Access Compliance Report

Public Rights-of-Way

(Pedestrian Signals)

Intersection ID: N/A	Main Street:	Cross Street: N/A	Location: N/A
ADA ID: 50C295F224D6	Signal Type: One Push Button-Non APS	Overall Compliance: No	Severity Score: BTN 1: N/A BTN 2: N/A No BTN: N/A
Codes/Mitigation Info/Possible Solution		Field Measurements/Component Compliance

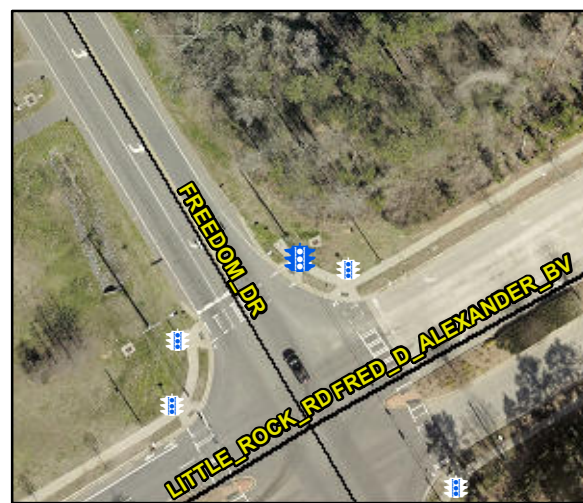
Possible Solutions: Replace Signal Push Button With APS Button on New Post. Remove & Relocate Sign.

PROW/ADA: TMUTCD 4e.08, R404.2, R404.3, R404.7.2

Compliance	Description	Data	Compliance	Description	Data
	Button Count	Button1	Yes	Distant to Additional Button (in)	318.0
	Additional Button Present?	Yes		Additional Button ID	81EF5E145F67
N/A	Signal Buttons Required?	N/A	N/A	Additional Ped Posts Required	N/A
	How Many Ped Street Xings?	N/A		Located In An Island/Median?	N/A
N/A	B 1 Sign Present?	Yes	N/A	B 2 Sign Present?	N/A
Yes	B 1 Sign Purpose?	Yes	N/A	B 2 Sign Purpose?	N/A
Yes	B 1 Sign Lettering & Contrast?	Yes	N/A	B 2 Sign Lettering & Contrast?	N/A
Yes	B 1 Parallel To XWalk?	Yes	N/A	B 2 Parallel To XWalk?	N/A
Yes	B 1 PAR to Button?	Yes	N/A	B 2 PAR to Button?	N/A
Yes	B 1 PAR to XWalk?	Yes	N/A	B 2 PAR to XWalk?	N/A
Yes	B 1 Clear Floor Space?	Yes	N/A	B 2 Clear Floor Space?	N/A
N/A	B 1 FWD Approach?	No	N/A	B 2 FWD Approach?	N/A
N/A	B 1 FWD Approach Constrained?	N/A	N/A	B 2 FWD Approach Constrained?	N/A
N/A	B 1 FWD Approach Reach (in)	N/A	N/A	B 2 FWD Approach Reach (in)	N/A

N/A	B 1 FWD Approach Width (in)	N/A	N/A	B 2 FWD Approach Width (in)	N/A
N/A	B 1 FWD Approach Obstruction?	Yes	N/A	B 2 FWD Approach Obstruction?	N/A
N/A	B 1 FWD Approach Obstruction Dist (in)	5.0	N/A	B 2 FWD Approach ObstructionDist (in)	N/A
N/A	B 1 PARA Approach?	Yes	N/A	B 2 PARA Approach?	N/A
N/A	B 1 PARA Approach Constrained?	Yes	N/A	B 2 PARA Approach Constrained?	N/A
Yes	B 1 PARA Approach Reach (in)	6.0	N/A	B 2 PARA Approach Reach (in)	N/A
No	B 1 PARA Approach Width (in)	48.0	N/A	B 2 PARA Approach Width (in)	N/A
N/A	B 1 PARA Approach Obstruction?	Yes	N/A	B 2 PARA Approach Obstruction?	N/A
N/A	B 1 PARA Approach Obstruction Dist (in)	6.0	N/A	B 2 PARA Approach ObstructionDist (in)	N/A
No	B 1 Clear Floor Space Slope (%)	5.4	N/A	B 2 Clear Floor Space Slope (%)	N/A
No	B 1 Clear Floor Space XSlope (%)	3.7	N/A	B 2 Clear Floor Space XSlope (%)	N/A
N/A	B 1 PAR Slope (%)	N/A	N/A	B 2 PAR Slope (%)	N/A
Yes	B 1 Height (in)	36.0	N/A	B 2 Height (in)	N/A

N/A	B 1 Clear Xing Direction?	Yes	N/A	B 2 Clear Xing Direction?	N/A
	B 1 Crossing Direction	To SW		B 2 Crossing Direction	N/A
Yes	B 1 DistanceTo XWalk (in)	6.0	N/A	B 2 DistanceTo XWalk (in)	N/A
No	B 1 DistanceTo Curb (in)	132.0	N/A	B 2 DistanceTo Curb (in)	N/A
Yes	B 1 Diameter (in)	2.0	N/A	B 2 Diameter (in)	N/A
